**TOWN OF BROOKLYN
PLANNING AND ZONING COMMISSION
Regular Meeting Agenda
Wednesday, June 2, 2021
6:30 p.m.**

**TOWN OF BROOKLYN
PLANNING AND ZONING COMMISSION
Regular Meeting
Wednesday, May 5, 2021
6:30 p.m.**

TYPICAL SECTION - UNREINFORCED RETAINING WALL
VERSA-LOK OR APPROVED EQUAL

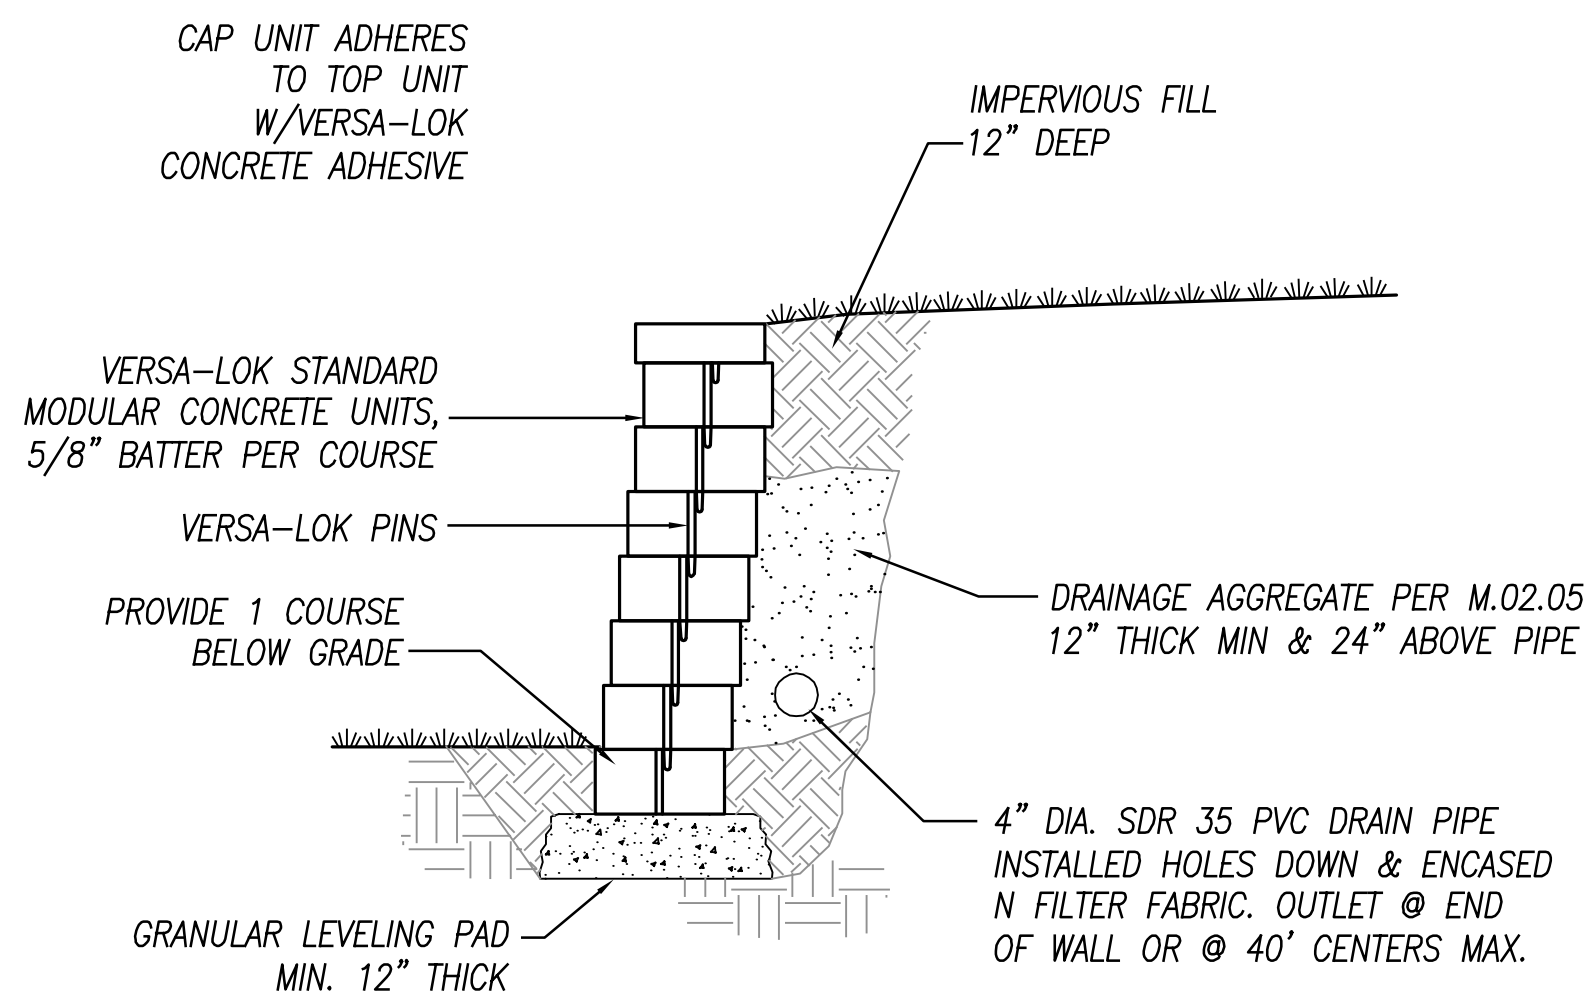
6. In front of Units 1-3, the plan shows that a "block retaining wall" is to be constructed opposite the units. Is this to be the Versa-Lok unreinforced retaining wall depicted on Sheet 8 of 8? If so, it should be labeled as such. Also, how are vehicles going to be prevented from driving over the top of the wall because there is no railing or fence shown to be installed to prevent this?

SEWER CONNECTION DETAIL
NOT TO SCALE

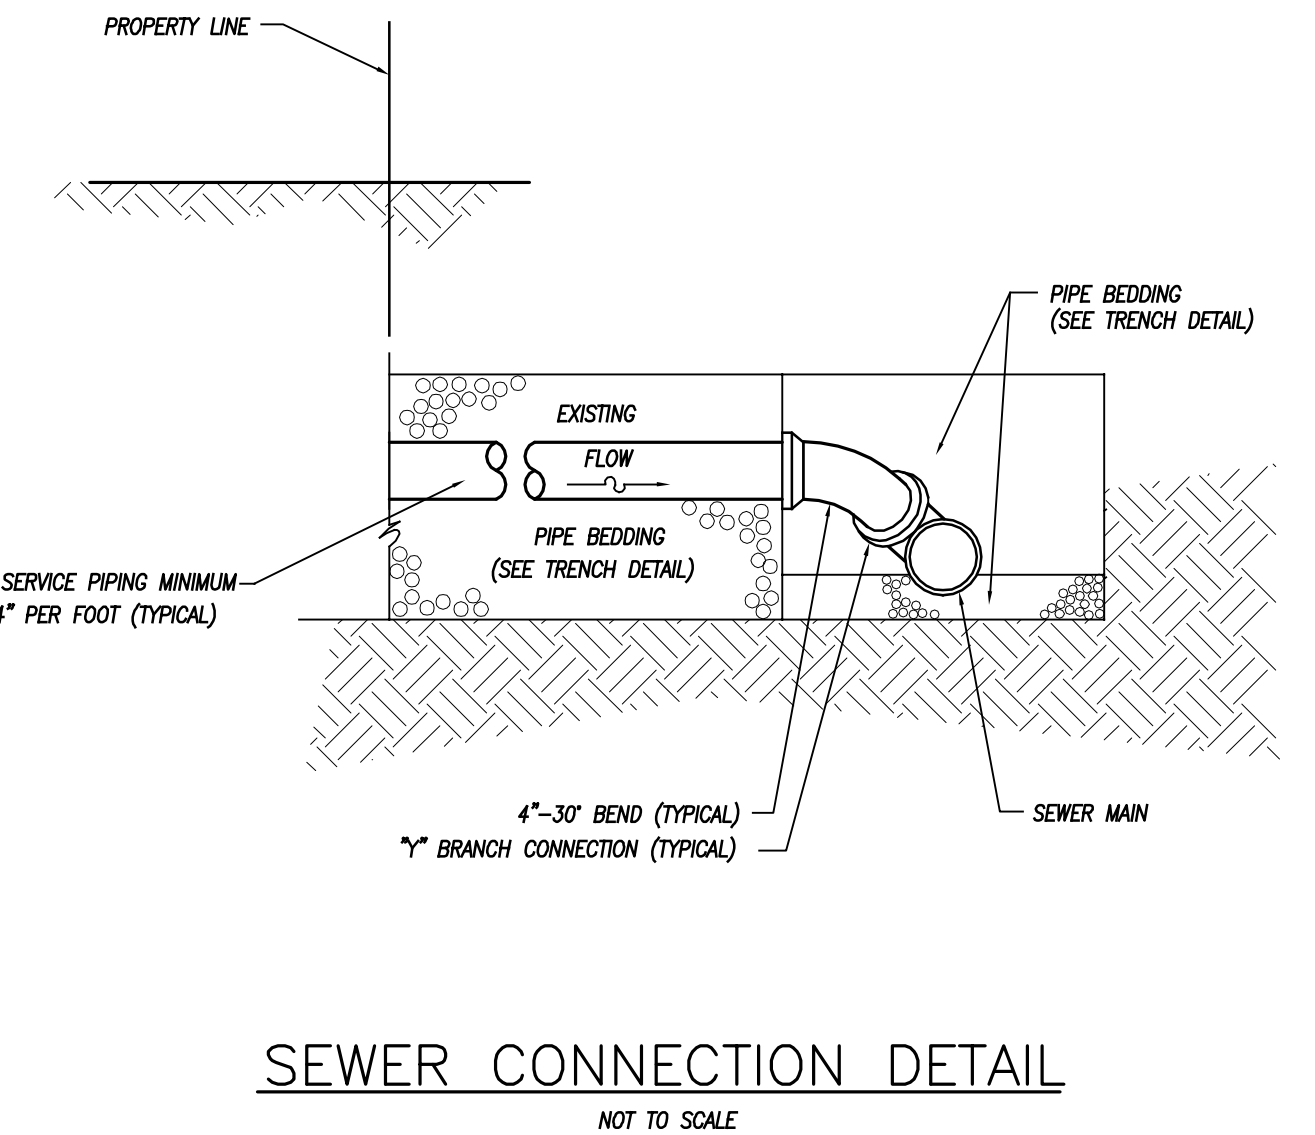
On plan Sheet 5 of 9, KEA has added an additional sanitary sewer manhole (S1) at STA 8+22.87 (8.12’ LT). However, if the connection of each housing unit (Nos. 1 – 3) to the sewer main is to be as depicted in the “Sewer Connection Detail” shown on Detail Sheet 3 (Sheet 9 of 9), then the sewer main needs to be extended further up the road and an additional sewer manhole constructed at STA 9+35, more or less.
